PLANNING BOARD MEETING AGENDA

6. **Major Stormwater Management Permit, Case No. 2023-07:** Applicant/Owner: Whiffletree LLC, through their representative Down Cape Engineering, Inc., has submitted a major stormwater permit application for property located at 0 Whiffletree Avenue and shown on Tax Map 6, Parcel 4, pursuant to Brewster Town Code Chapter 272 and its accompanying Regulations. The Planning Board will consider and potentially vote whether to approve the major stormwater permit.

TO: Planning Board
FROM: Jon Idman, Town Planner
RE: Major Stormwater Permit SWMP23-7
Whiffletree Avenue (Map 6 Parcel 4)
Applicant, Whiffletree LLC
c/o Dan Ojala, PE, PLS, DownCape Engineering, Yarmouthport, MA
DATE: April 14, 2023

**PROPOSED
RAIN GARDEN
PLANTING DETAIL**

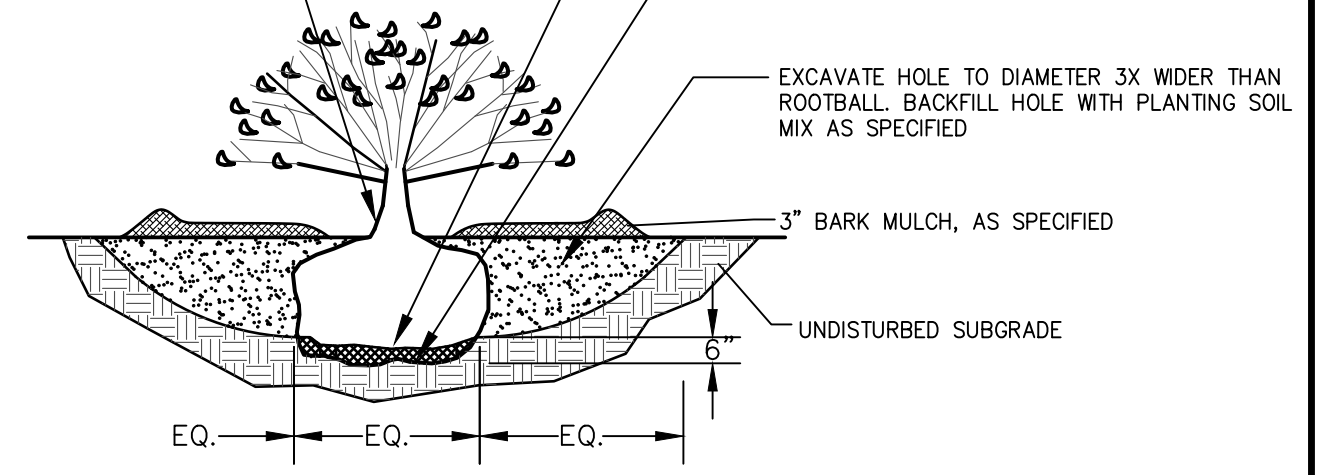
1. I don't see the grass channel location denoted on the site plan. I assume that the grass channel is what is supposed to convey site run-off (but more importantly the driveway run-off) to the forebay pre-treatment, then to the rain garden, etc. in the north part of the site.
2. Is the north forebay/ rain-garden sized to store the 1st inch of run-off from the driveway? Under the Brewster regs, this is the primary way to evidence TSS/ TP treatment for new construction. I understand that the MA handbook is a bit different and you can largely rely on O&M in the Handbook to meet treatment reqs.
3. I also assume NRCS has the soil type on-site as Plymouth or the like?
4. Are you going to provide a plant list for the rain garden?

4. We typically spec bayberry and winterberry plans for rain garden areas. Let me know if you need a planting schedule addendum.

TEST HOLE LOGS

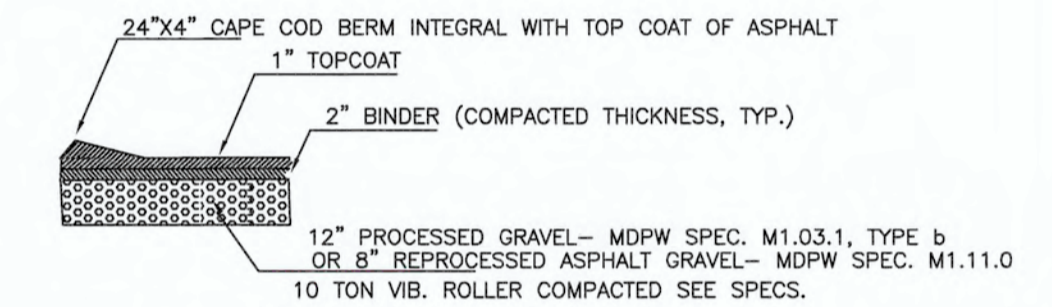
- 1) Soil logs provided show no groundwater observed down to at least el 28. Is there sufficient free board for the leaching facilities connected to the bioretention? It looks like the bottom of the leaching facilities would be around el 15?
